License Amendment Request NFPA 805 Acceptance Review

Arkansas Nuclear One Unit 2

June 12, 2012

NRC four areas of concern with the LAR

Table W-2 ANO-2 Fire Area Risk Summary

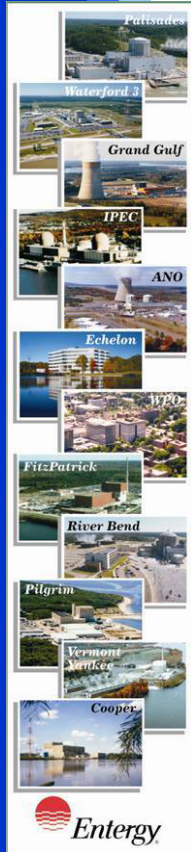
About one third of the fire areas in the "Additional Risk of RAs" column of Table W-2 of the LAR do not contain a quantitative risk result. The LAR needs to be supplemented with all of the quantitative Recovery Action risk estimates to demonstrate that the evaluations supporting the transition have been satisfactorily completed.

- The delta risk from recoveries are currently being drafted and preliminary results are available for review
- An example of the information to be provided in the Supplement to the ANO-2 LAR is contained in the next slide

Revised Column for delta risk of Recovery action only
